ADDENDUM NO. 1

Date: June 2, 2008

Subject: Bid Documents

Project: Modifications to the West Virginia State Capitol Parking Facility
 PROJ. NO. WV GSD086428

2/A-1
DRAWING NO.

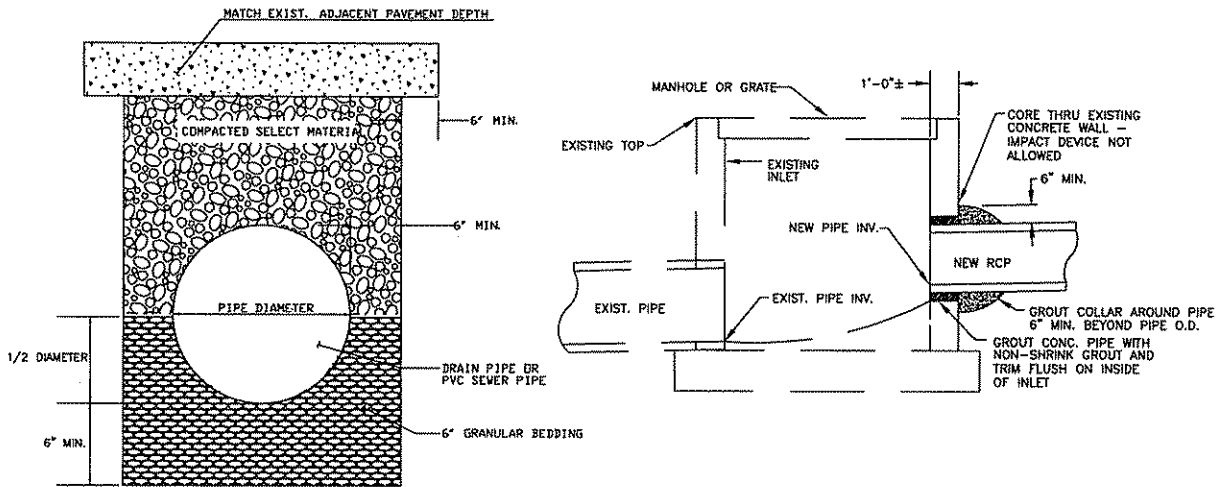
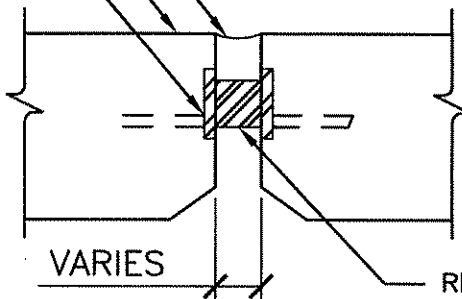
ADD THE ATTACHED DRAWING 2/A-1

Additive Alternate to supply all materials and provide all work associated with preparing and installing a new 24" x 24" precast drop inlet per drawing 2/A-1 in this addendum. Work includes 126' of 8" traffic rated corrugated metal piping to attach new inlet to existing drop inlet per details on 2/A-1. Trench new line thru existing asphalt paving area and patch paving as per details. Assumes maximum trench depth of 36".

1 (S-9R1) (REVISED) - TYPICAL TEE FLANGE - REMOVAL DETAIL

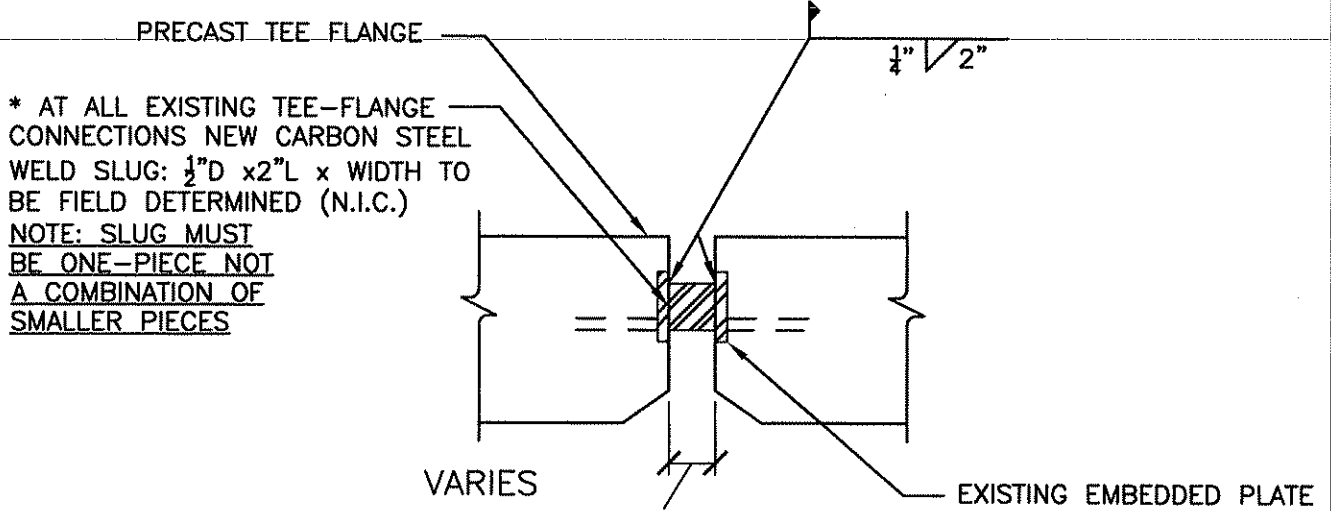
CHANGE BASE REPAIR DETAILS 1/S-9 and 2/S-9 as indicated on attached supplemental drawings S-9R1 and S-9R2.

- 1.) EXCEPT FOR SEALANT REMOVAL. ALL WORK IS NOT-IN-CONTRACT (N.I.C.) TO BE PERFORMED BY A CONTRACTOR ASSIGNED BY THE OWNER.
- 2.) WHERE * IS INDICATED - ASSIGNED CONTRACTOR PERFORMING THIS WORK MAY ALTERNATIVELY PROVIDE WELD TESTING REPORTS FROM AN INDEPENDENT AGENCY TO SHOW WHICH EXISTING WELD SLUGS ARE ADEQUATELY WELDED WITH NO DEFECTS AND THUS MAY REMAIN IN PLACE. OTHERWISE REPLACE ALL WELD SLUGS AT ALL TEE-FLANGE CONNECTIONS.

3.) SEE TYPICAL DETAILS ON SUPPLEMENTAL DRAWING S-10R1 AND S-10R2 FOR PREPARATION AND REPAIRS AT WELD POCKETS.

S-10R1
DRAWING NO.
SHEET 1 OF 1

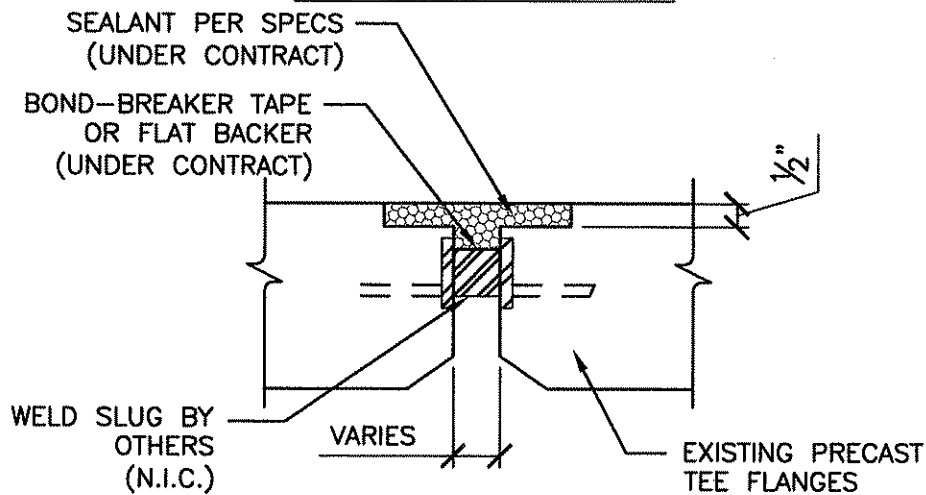
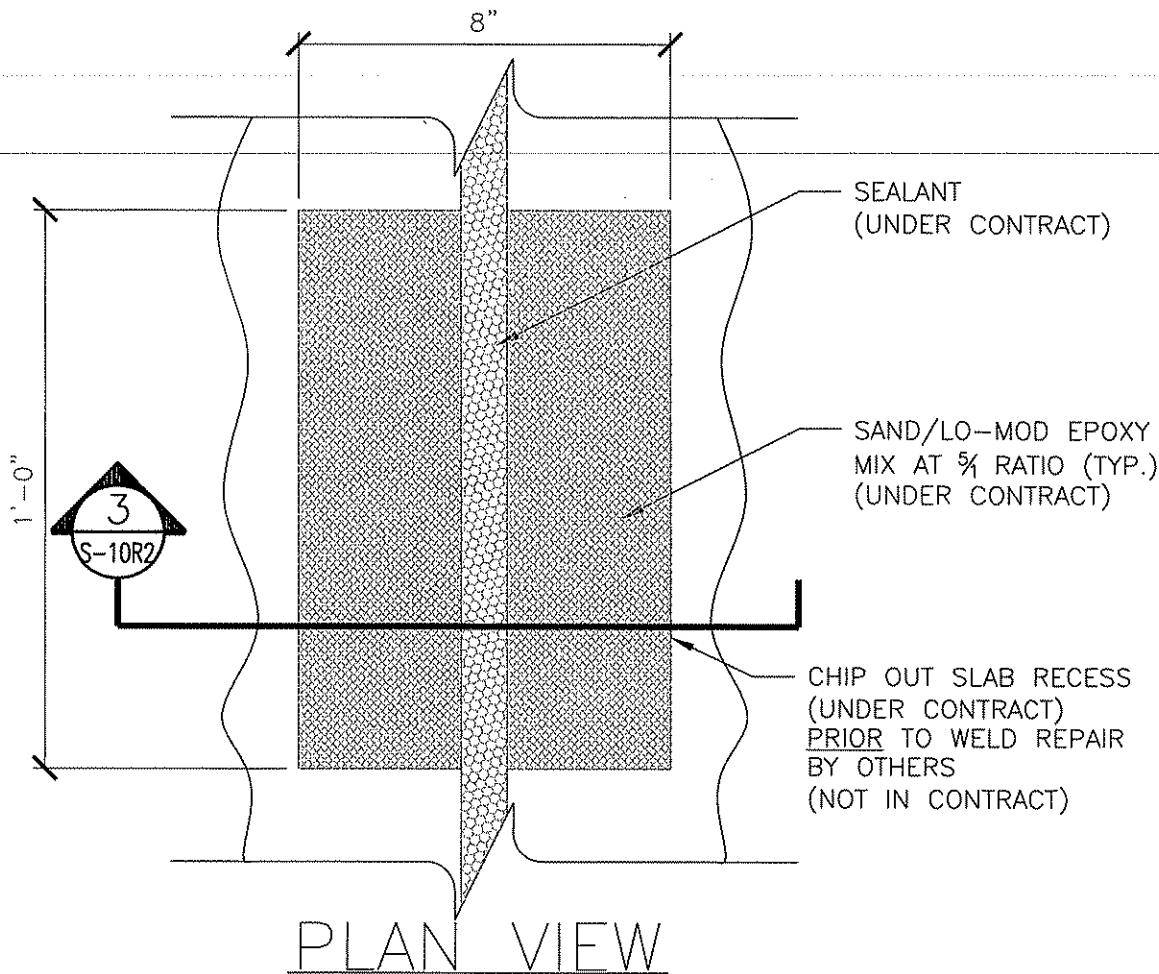
ADD TYPICAL REPAIR AT SLAB WELD POCKET DETAILS as indicated on attached supplemental drawings S-10R1 and S-10R2

CHIP OUT SLAB RECESS
(UNDER CONTRACT)
PRIOR TO WELD REPAIR
BY OTHERS
(NOT IN CONTRACT)

SEALANT PER SPECS
(UNDER CONTRACT)

CASE 1: "MINOR" REPAIR, BID
QTY=2,000 LOCATIONS

1 (REVISÉD) - TYPICAL SLAB JOINT
 S-10R3 SEALANT AND SLAB COATING

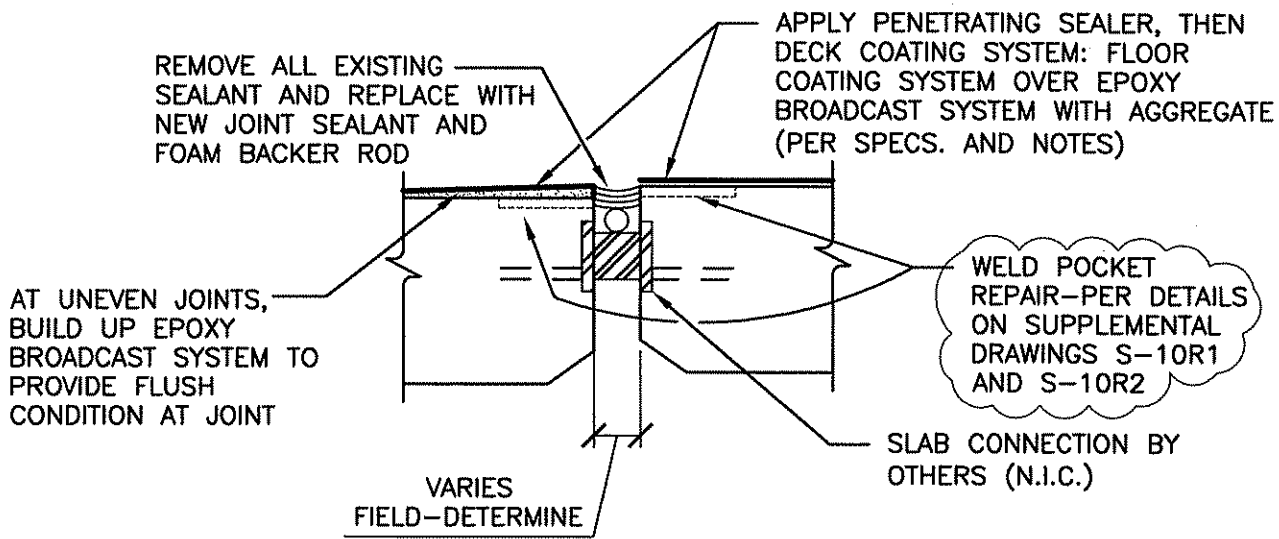
CHANGE TYPICAL SLAB JOINT SEALANT AND SLAB COATING DETAIL as indicated on attached supplemental drawings S-10R3.

- 1.) PROVIDE SIMILAR DETAIL AT JOINTS IN CAST-IN-PLACE POUR STRIPS.
- 2.) SEE PLANS FOR LEVELS TO RECEIVE SLAB COATING.
